Field Service Information

GSM V80 No display issue

Our Reference: SI66_21_2004

Subject: **V80 No display issue**

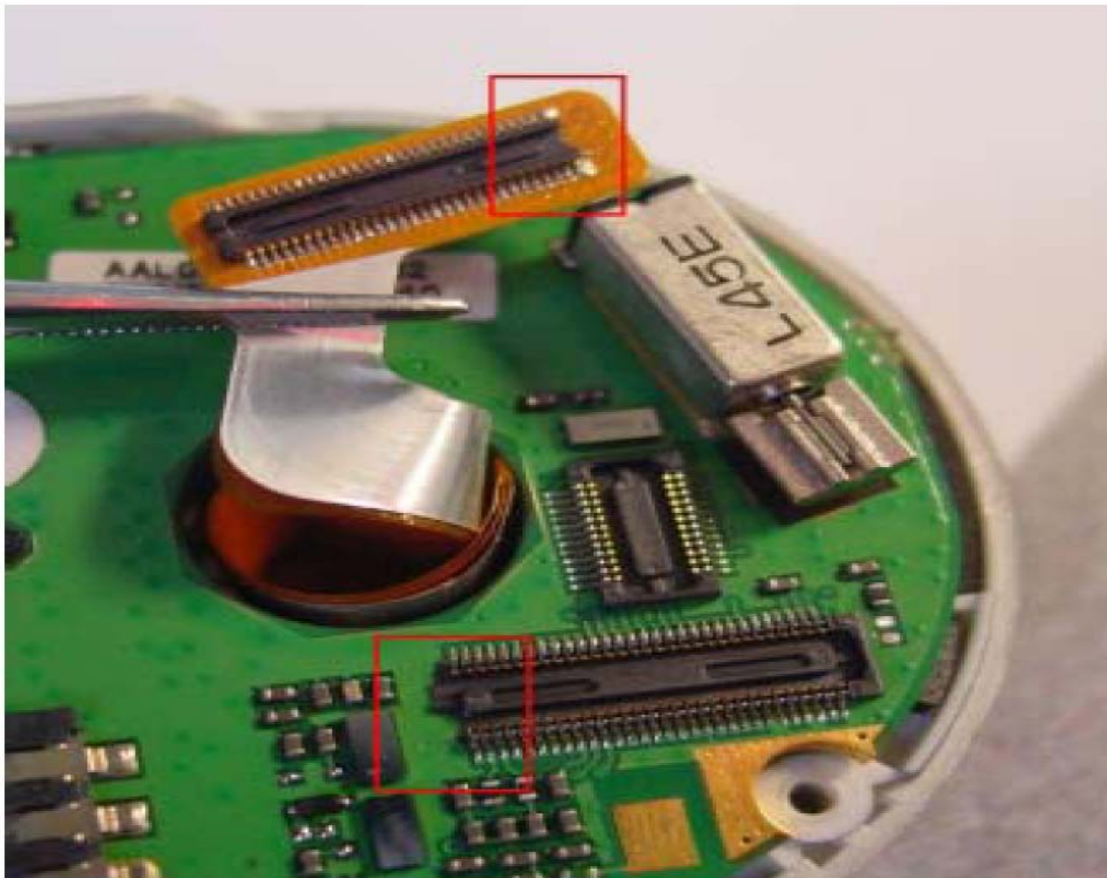
Shanghai Forte service center reported that V80 connector is crack and cause no display, please see attached photo.

SDC has a solution for connector issue. A new revision (Rev B) of connector has been qualified on Nov. 18. Old revision is rev O. The revision information can be identified from the flex cable connector's back.

1. Power up the phone and verify the following symptom: the units display is no display, if the unit does not display these symptoms then proceeds with normal troubleshooting techniques per customer complaint.
2. Disassembly the flip assembly and verify that the failure is caused by above issue.
3. Replace the defective flex connector and reassemble the units, retest to confirm the repair.
